#### **Addendum 52 – UN Regulation No. 53**

#### **Revision 4 – Amendment 2**

Supplement 2 to 02 series of amendments – Date of entry into force: 15 October 2019

#### **Installation of lighting and light-signalling devices for L<sub>3</sub> vehicles**

**Observing area towards the apparent surface of exterior  
courtesy lamps**

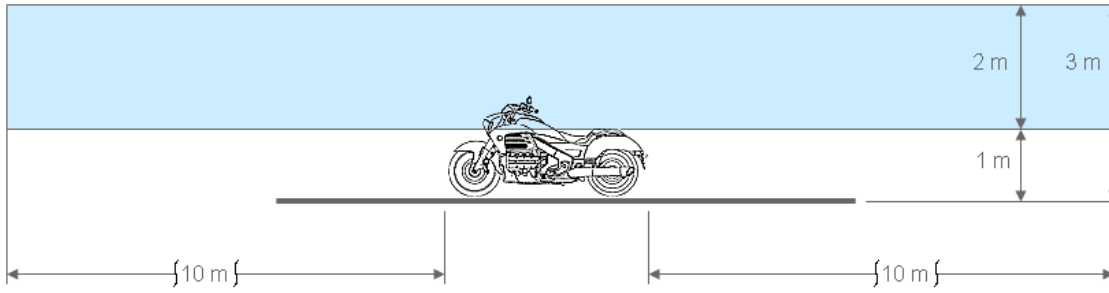
*Insert a new Annex 7, to read:*

This drawing shows the zone from one side, the other zones are from the front, the rear  
and from the other side of the vehicle.

- 6.15.9.3. The technical service shall, to the satisfaction of the Type Approval Authority, perform a visual test to verify that there is no direct visibility of the apparent surface of the exterior courtesy lamps, if viewed by an observer moving on the boundary of a zone on a transverse plane 10 m from the front of the vehicle, a transverse plane 10 m from the rear of the vehicle, and two longitudinal planes 10 m from each side of the vehicle; these four planes to extend from 1 m to 3 m above and perpendicular to the ground as shown in Annex 7.
